TECHNICAL BULLETIN
Bell Helicopter **TEXTRON**

No. 407-03-46

MODEL AFFECTED: 407

SUBJECT: TUNING WEIGHTS 407-023-003-(ALL), REMOVAL OF

Figure 1. Tuning Weights Removal

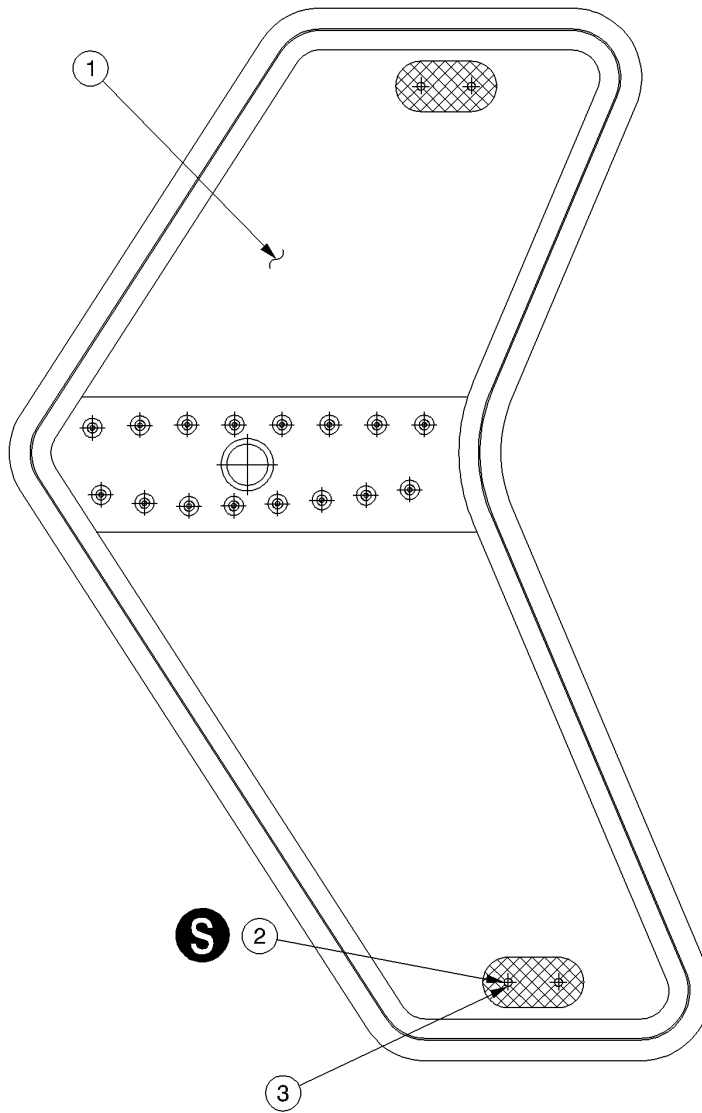
Bell Helicopter has determined that the tuning weights 407-023-003-(ALL) installed on the horizontal stabilizer finlet are no longer required.

This bulletin gives instructions to remove tuning weights. The new finlet assembly 407-023-003-105 and /-106 have no provisions for tuning weights, and are direct spares replacement for the current finlet assembly 407-023-003-101, / -102. Both R/H and L/H finlet must have the same configuration. New and old finlet assemblies can be mixed, but weight on the old finlet assembly must be removed.

1. Refer to BHT-407-MM-5, chapter 53, paragraph 53-31 to remove weights. Discard screws, washers and weights.

Make sure the blanking screws do not bottom in the inserts of the finlet(s).

2. Install qty (2) blanking screws AN525-10R5 and qty (2) washers NAS1149D0332J wet with sealant (C-392) on the top and bottom of the finlet(s) as shown in figure 1.

Maximum weight of painted finlet only, not to exceed 4.9 pounds, not including phenolic block (0.1 pounds) and position light assembly (0.3 pounds).

3. Touch up paint to match your helicopter as shown in figure 1.
